Development Services

APPEAL SUMMARY

Appeal ID: 23422	Project Address: 10101 NE Alderwood Rd
Hearing Date: 2/5/20	Appellant Name: Ryan Weston
Case No.: B-015	Appellant Phone: 503-224-9560
Appeal Type: Building	Plans Examiner/Inspector: Jeff Donnelly
Project Type: commercial	Stories: 1 Occupancy: S-1, F-1, B Construction Type: V-B
Building/Business Name: Eyelevel	Fire Sprinklers: Yes - Entire Space
Appeal Involves: Reconsideration of appeal	LUR or Permit Application No.:
Plan Submitted Option: pdf [File 1] [File 2]	Proposed use: Warehouse and Fabrication

SHEET TITLE:
OCCUPANCY
AND PLUMBING
FIXTURE
EXHIBIT

Reconsideration floor plan

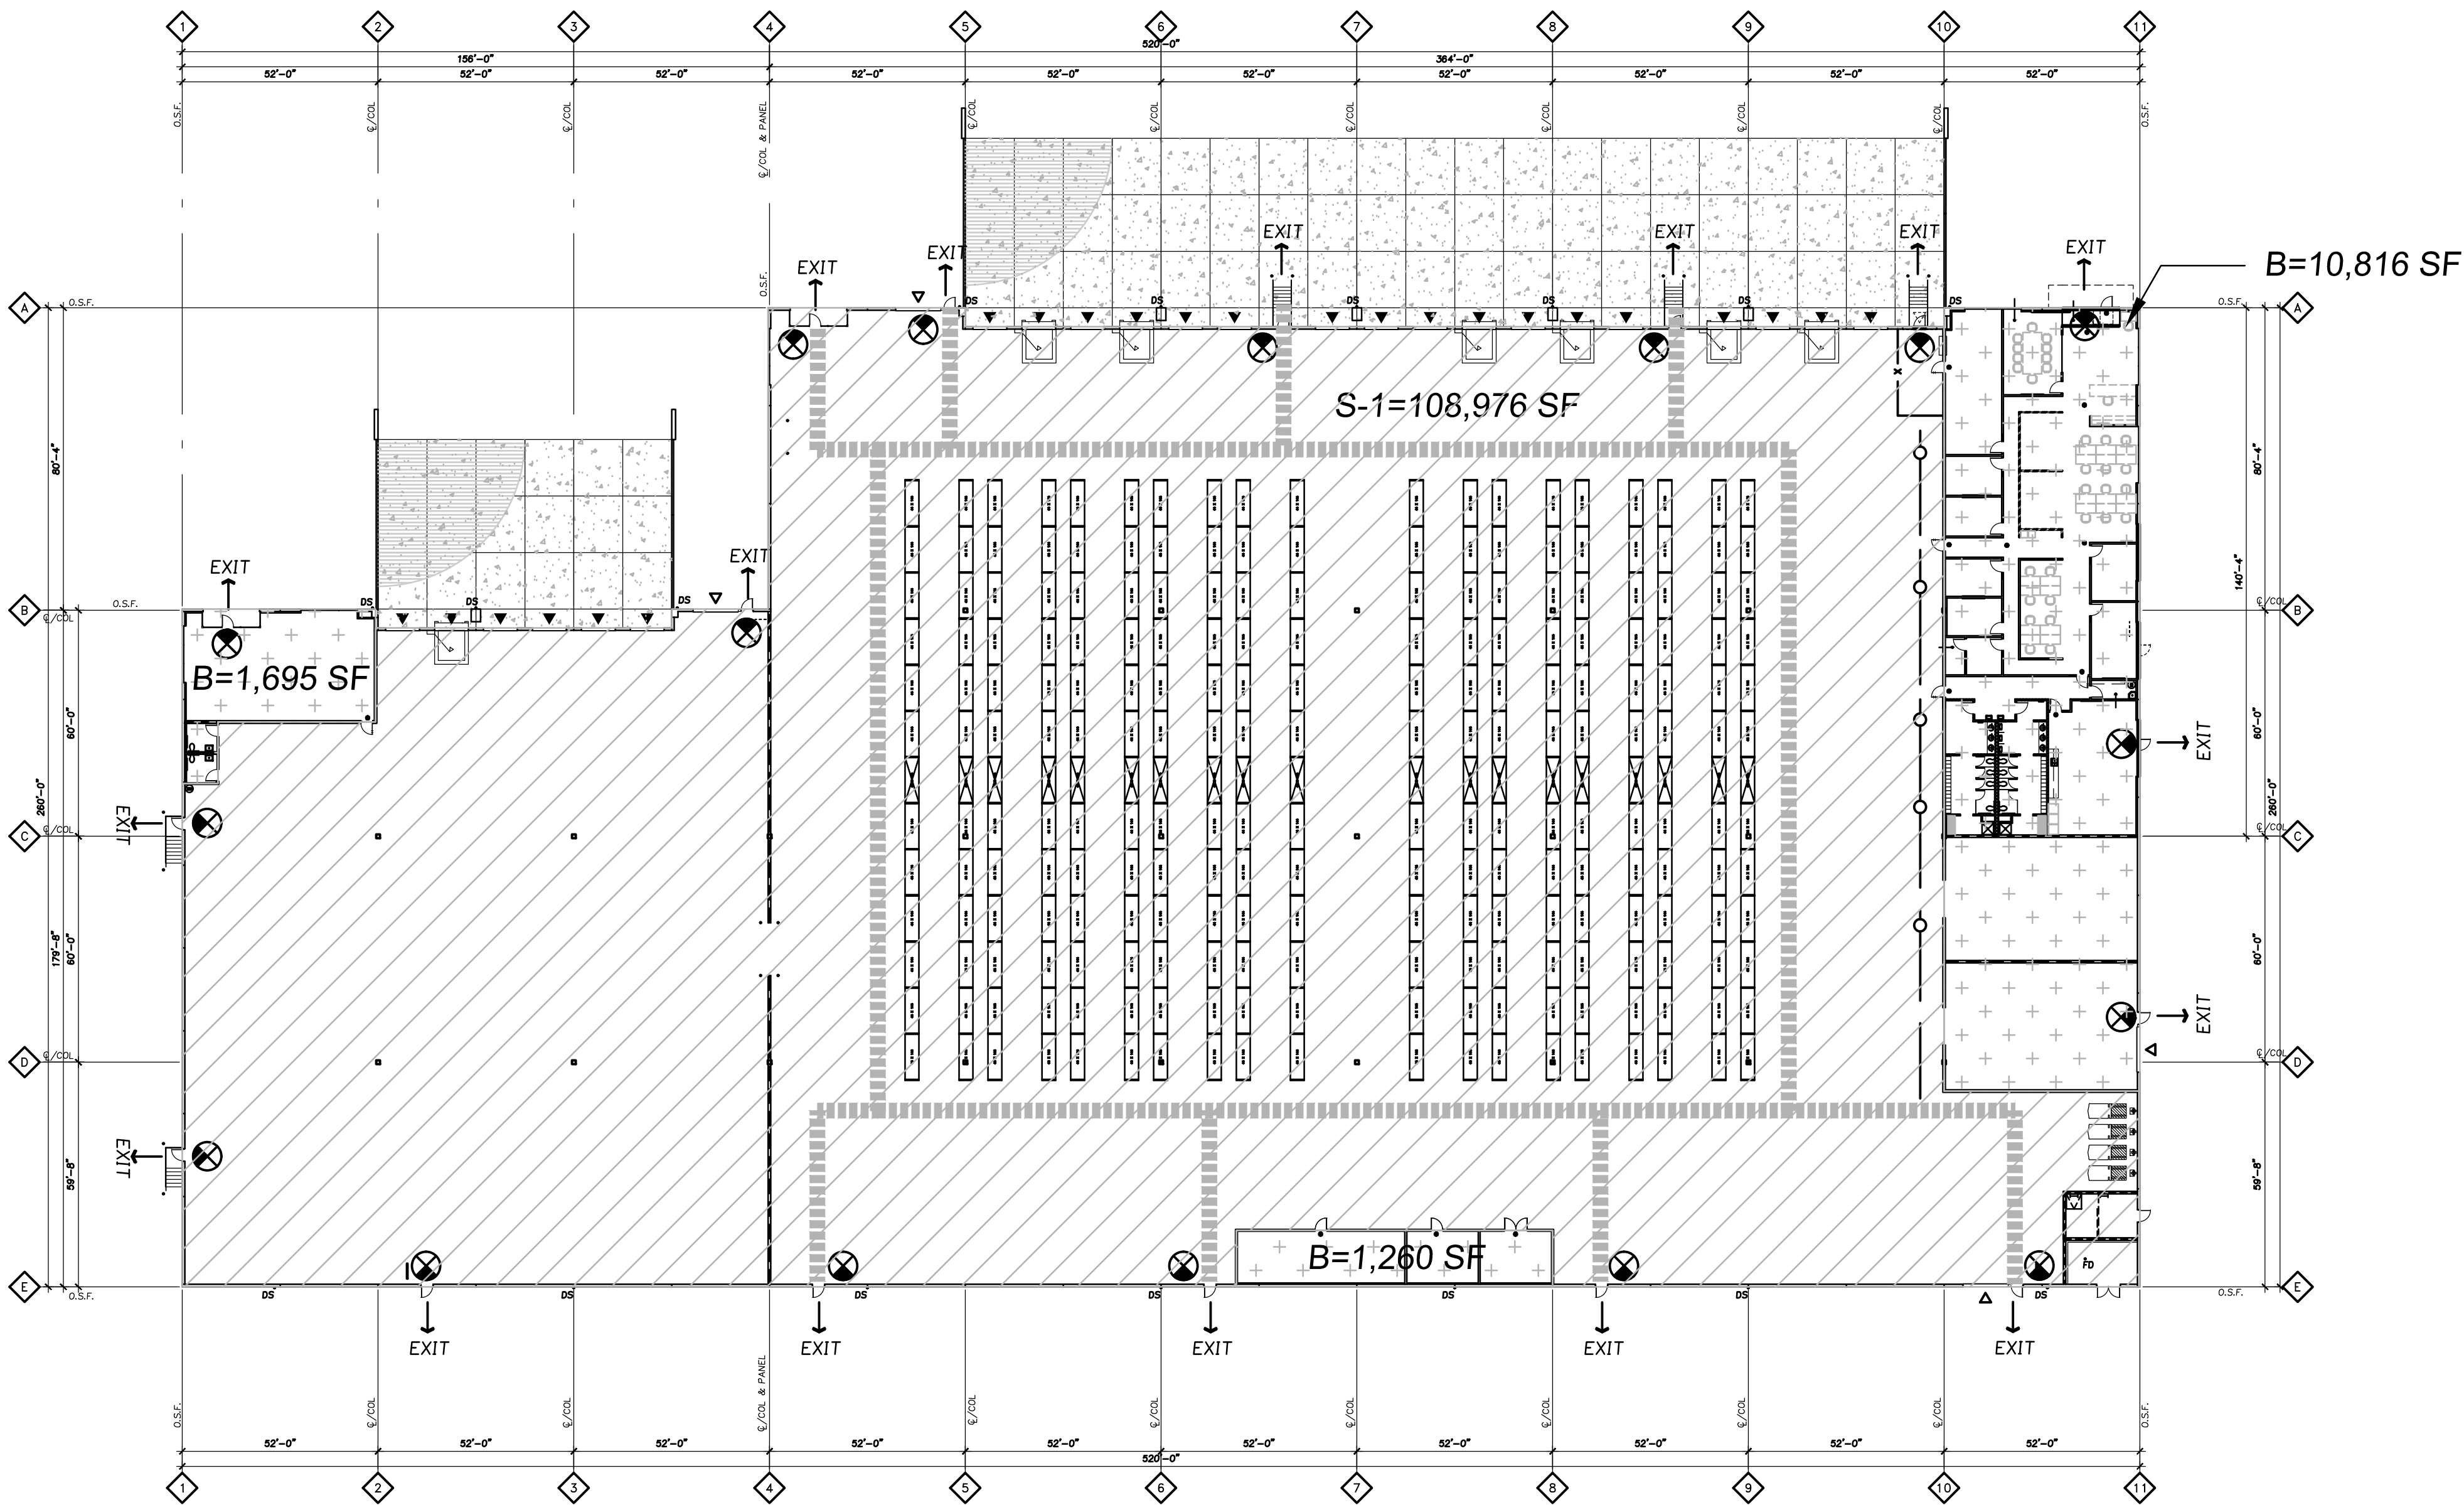
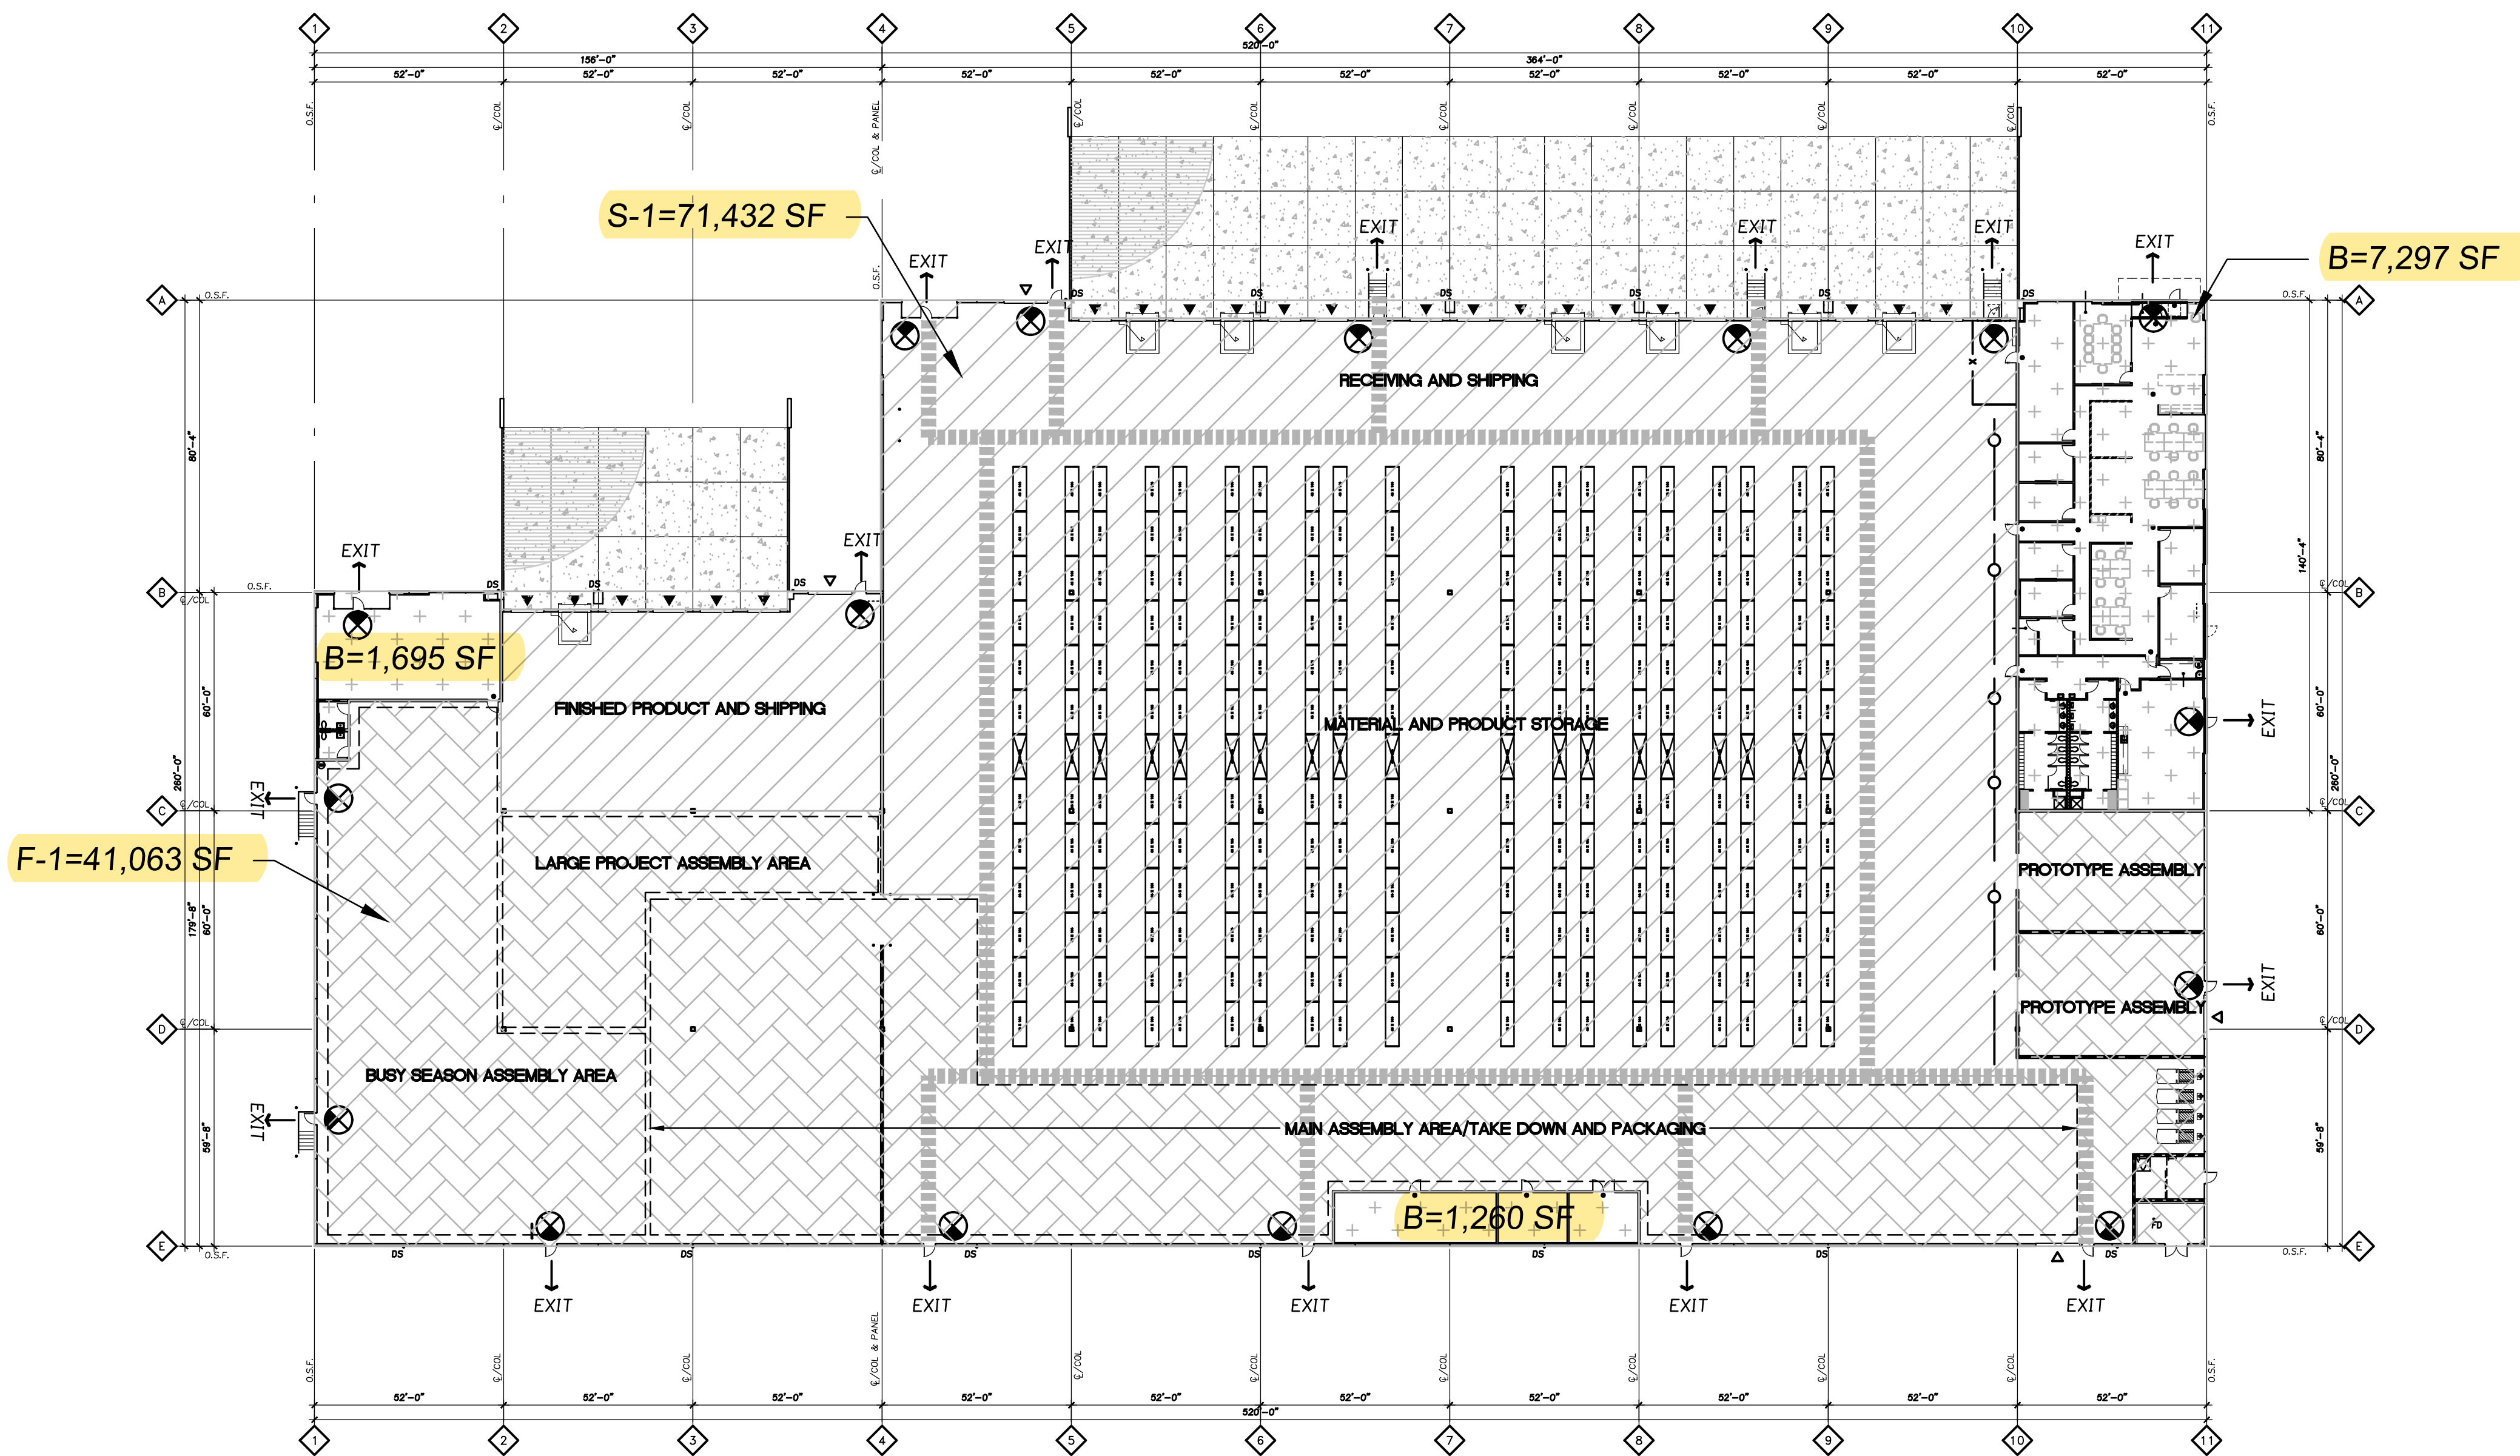
Base plumbing calculations on F-1 occupant load of 200 SF per occupant.

B occupancy 10,252 SF (103 occupant load) - 2.03 water closets per sex and 1.29 lavs' per sex

F-1 occupancy 41,063 SF (206 occupant load) - 1.03 water closets per sex and 1.03 lavs' per sex

S-1 occupancy 71,432 SF (143 occupant load) - 0.72 water closets per sex and 0.72 lavs' per sex

Total required fixtures: 4 water closets per sex and 4 lavatories per sex.

Based on further discussions with the tenant and layout of their facility the manufacturing areas were reduced, see attached EX 1-Model rev_1.24.20.pdf showing the revised layout and production areas. The tenant also further explained that there is no equipment used for their production, just assembling furniture and display pieces with basic hand tools; since these are large pieces limited tables are used and typically just done on the floor. The PDF shows the different production areas which helped define the MFR area. With the larger foot print of the product pieces we would like to propose a higher occupant load factor for the F-1 area in lieu of excluding it from the plumbing fixture counts.

Reduction in minimum required number of plumbing fixtures: Granted as proposed.
